A message from Technical Standards

CitiPower/Powercor Technical Standards Update for September 2019

Figure 1

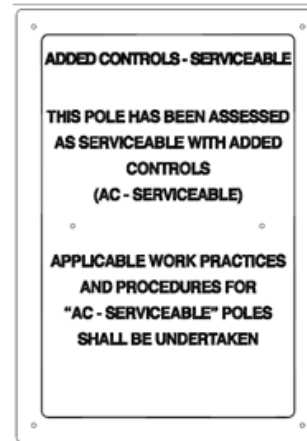
- Technical Standard DS101 have been updated to include:
 - New “Added Controls – Serviceable” (AC-Serviceable) signage. This signage replaces the “Limited Life” signage (figure 1).
 - Enlarged pole reinstatement sign (figure 2)
 - New “AC-Serviceable” terminology to reinforced pole signage (figure 3)
- Technical Standards DS966, 972 and 996 have been updated to include new signage material

- The standards have been updated to align with 450 Asset Inspection Manual, where the term “limited life” is no longer used and has been replaced with “Added Controls – Serviceable”.
- The enlargement of the pole reinstatement sign has occurred to cover the “X” marked on poles when the pole has been assessed to be serviceable.

Figure 1 – HV gas switch

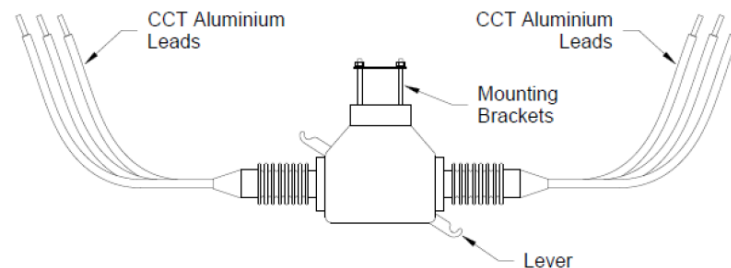
- Technical Standard EM016 has been updated to include:
 - The provision for two new future automation HV gas switches, 22kV 400A and 11kV/6.6kV 630A. Future automation gas switches come with motor pack attached but no controller. The controller can be added to the switch in the future to make the switch remote controllable.
 - Reference to the VESI Switchgear Operating Manual
 - Minor amendments to the switchgear rating details in table 1
- Technical Standard EM021 has been updated to include:
 - Reference to EM016 for future automation requirements
 - Reference to the VESI Switchgear Operating Manual
 - Minor amendments to the switchgear rating details in table 1
- Technical Standards EM861, 865 and 867 have been updated to include material information related to the future automation HV gas switchgear

- The standards have been updated to allow HV gas switches to be automated in the future with minor modifications to the installed switch.

Figure 1 – Hybrid arrangement

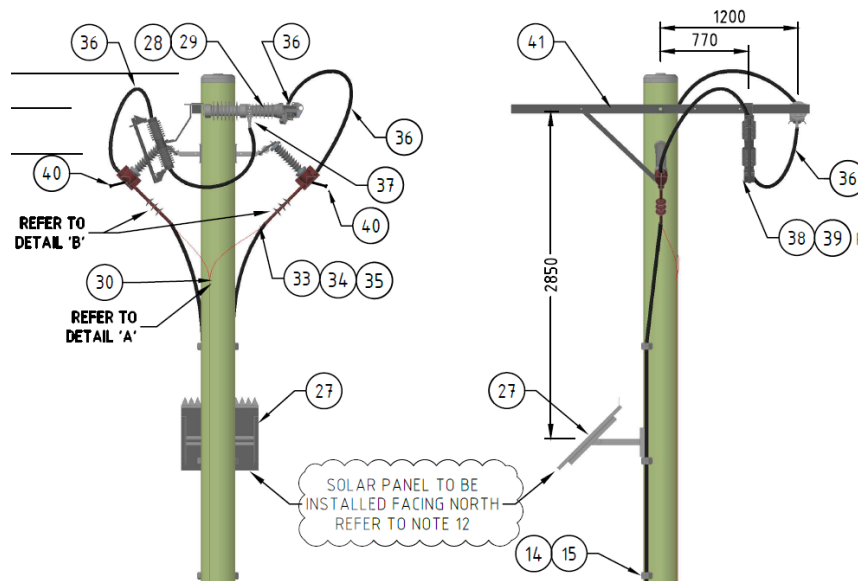
- Technical Standards GH001 and Standards Construction Drawings GH403 and GH404 have been updated with Note 12 which provides further guidance on the installation of solar panels

- The standards have been updated due to solar panels being installed incorrectly in the field resulting in reduced battery life on the RCU control box
